REVISION TRANSMITTAL

This sheet transmits Revision 1 to SL525C-34-10, which:

NAVIGATION - DISABLE FMS TEMPERATURE COMPENSATION AND IMPLEMENT AIRPLANE FLIGHT MANUAL (AFM) CHANGES FOR LNAV/VNAV

525C (CJ4)

Switch Access
Figure 1

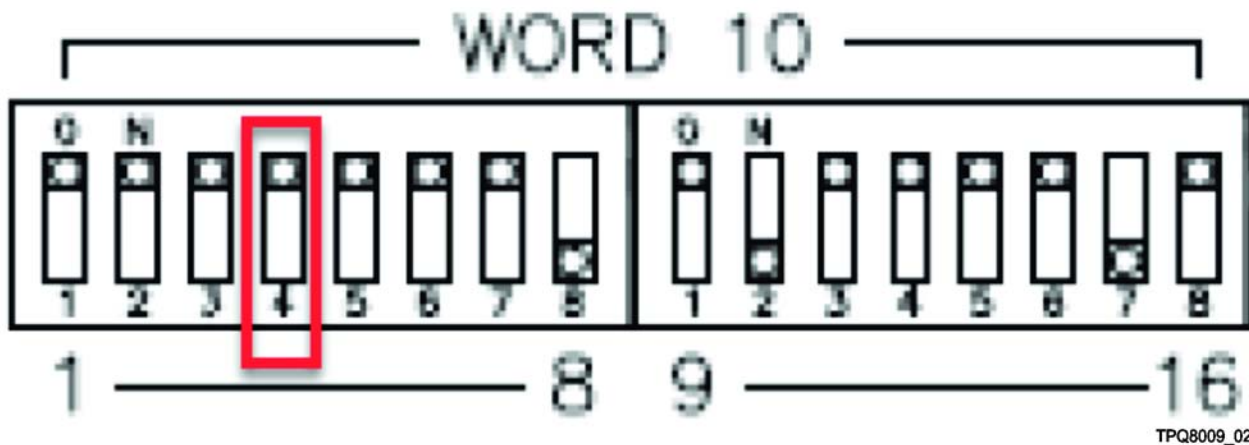
- (3) The CSU-XX00 consists of 256 strapping options organized in a 16x16 array of switches. Each word (row) of the array contains 16 straps.
- (a) Refer to Figure 1. Loosen the screws and slide the cover in the direction of the OPEN arrow. This will allow access to the switches. Further information regarding the CSU-XX00 may be found within the applicable Rockwell Collins Avionics Systems Manual for the aircraft.

Word 10, Switch 4 "UP" Position
Figure 2

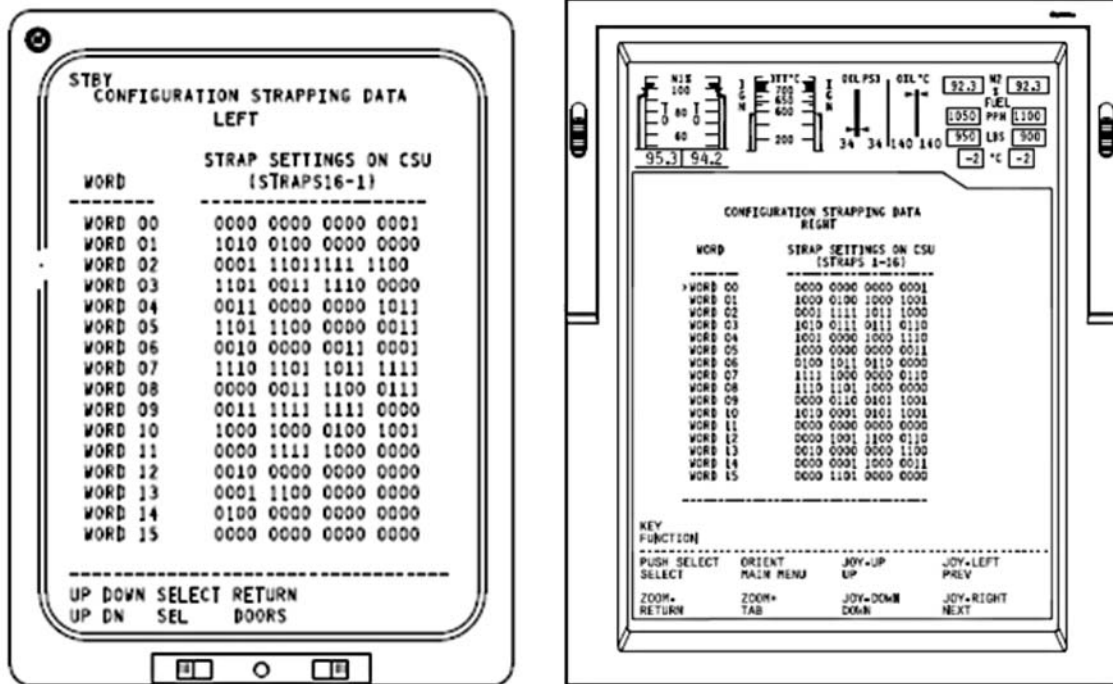
- (b) To disable the Automatic Temperature Compensation feature, Word 10, Switch 4 must be placed in the "UP" (UP = LOGIC 0) position. If Switch 4 is already in the "UP" position as shown Figure 2, no action is required. The proper orientation of the CSU is as shown in Figure 2.

- (c) Do NOT change any other switch settings. The settings of other switches may not match what is depicted in Figure 2. This is normal as these settings may vary based on other options within the aircraft.
- (d) Slide the CSU cover closed and secure by tightening screws.
- (4) Replace the CSU-XX00 units within the IAPS and perform return to service tests per the Aircraft Maintenance Manual instructions.

CONFIGURATION STRAPPING DATA Page
Figure 3

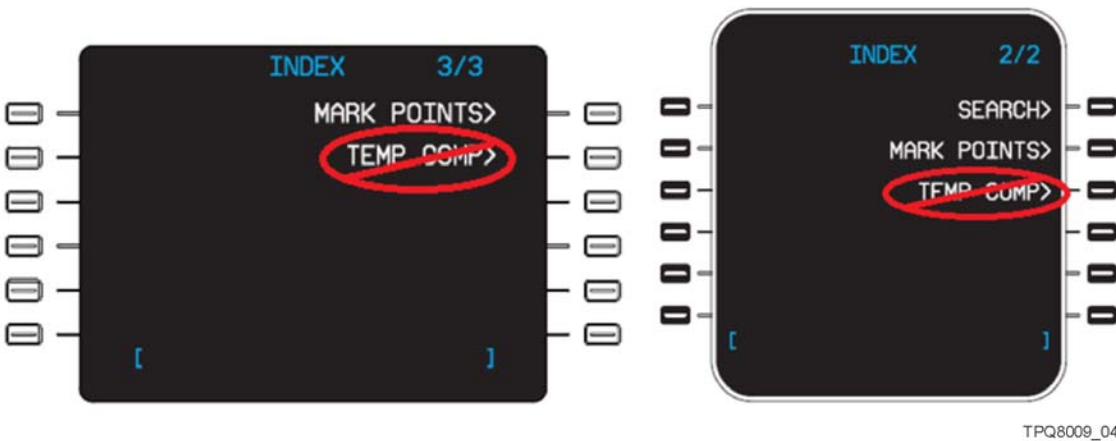
- After proper reapplication of aircraft power, refer to the Aircraft Maintenance Manual or aircraft specific Rockwell Collins Diagnostic Guide, for access to the CONFIGURATION STRAPPING DATA Page. View both the Left and Right CSU settings and confirm that they are identical. Refer to Figure 3. Instructions for accessing this data vary by aircraft.
